Determination 2017/034

The refusal to issue a code compliance certificate for a townhouse in a 24-year-old building with monolithic cladding at 6/22 Killarney Street, Takapuna, Auckland

Figure 1: Approximate site plan

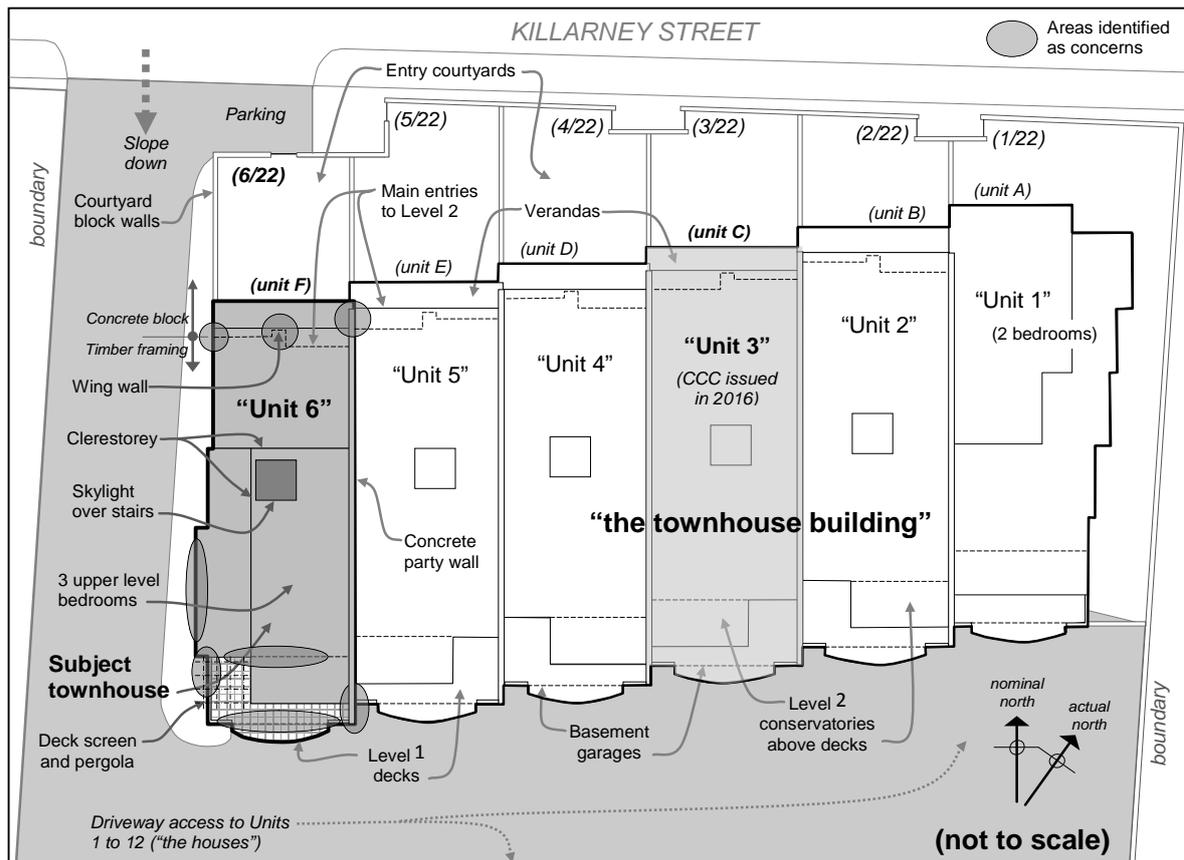
2.2.2 Unit 1, at the eastern end has two bedrooms with a partial upper level, while Units 2 to 6 have three bedrooms with a full upper level as shown in Figure 1.

- 2.4.1 Unit 6 is at the west end of the townhouse building as shown in Figure 1, with construction as described above except for the west elevation – where external walls are timber-framed above the basement blockwork. The concrete block party wall to the east extends to the south to form a barrier between adjacent decks. The Level 2 conservatory extends over the deck from the party wall, supported by a reinforced concrete beam at the south west corner.
